Type RQ
Webster ISB

Shop Drawing Submittal Review

Project Name: Webster University-**ISB**

Copies	No.	Description
1 PDF	265200E01A	(Submittal No.'s:) (R&B CxSRC)
		(Cannon #265200-006) - ~~(Paric #15051-)~~ – ~~(WES #607)~~
		➢ **Outdoor Lighting Final Fixture Package - Resubmittal**
		EB, EC, ED, SA, EF36, EF42, EH, EL, and RQ

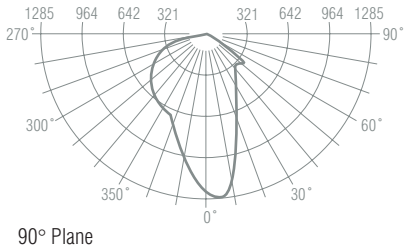
1. **Refer to previous shop drawing submittals for previous shop drawing comments.**
2. Type EC: See attached cutsheet for updated configuration.
3. Type EF36/42: Provide Bronze finish.
4. Type EL: Provide Black finish.
5. Type RQ: Provide 277 volt configuration.
